*ADDENDUM NO. 1*

*POKAGON BAND OF POTAWATOMI INDIANS*

*POKAGON COMMUNITY CENTER*

*July 27, 2010*

**1 LOUNGE BUILT-IN CASEWORK**  
 AD1 SCALE: 1/4" = 1'-0"

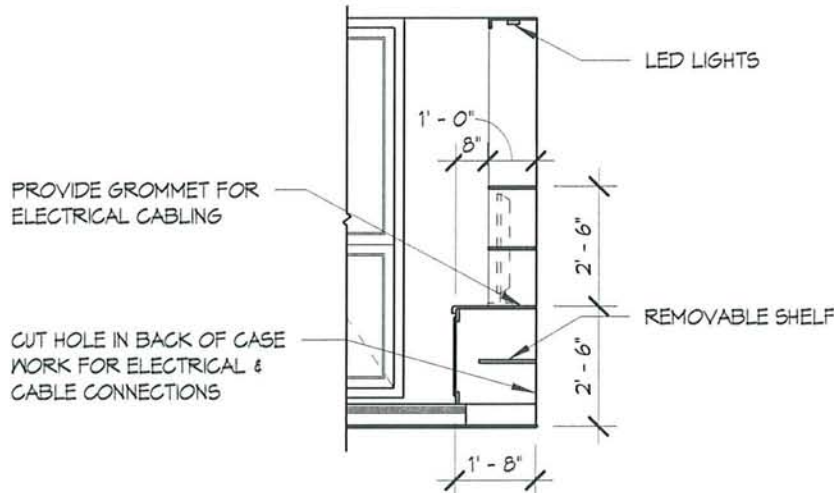
- A5. Refer to the attached sketch, X6174-AD1
- Add casework to lounge; see attached casework plan
- A6. Refer to the Roof Plan, sheet X6174-A1.3
- The live roof system is to be repositioned and is to increase from 1,288 sft to 1,473 sft in area.

**SK-M1**

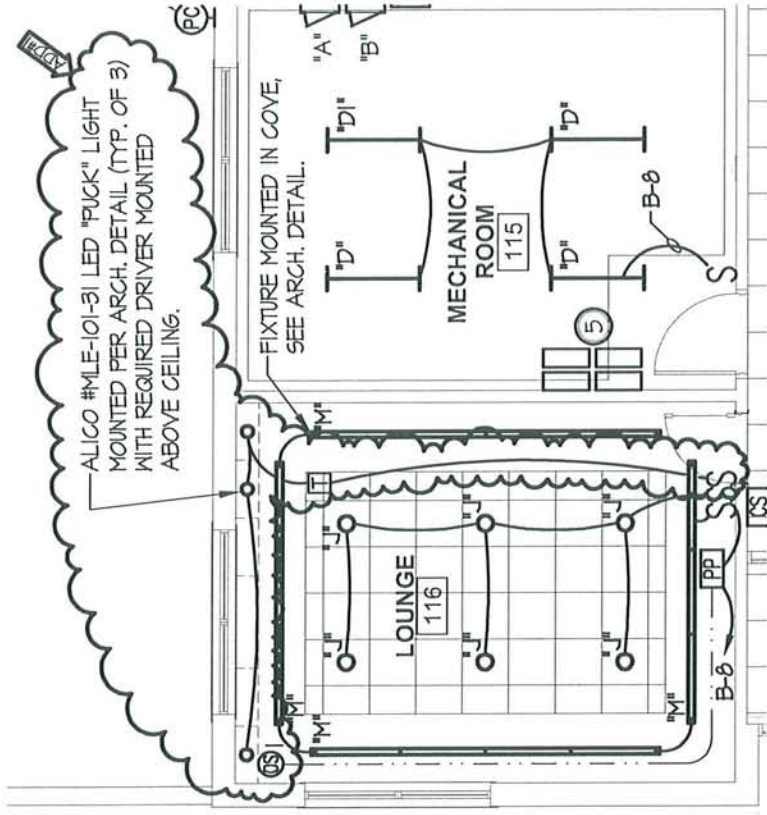
- Item M4: Refer to sheet M2.0, Boiler Piping Detail 9/M2.0 and attached sketch SK-M1.
- Revise detail as shown within revision cloud on attached sketch SK-M1.

**NOTE:**  
CLOSE MAKE-UP WATER VALVES AFTER SYSTEM IS CHARGED WITH GLYCOL. LABEL MAKE-UP WATER VALVE ACCORDINGLY.
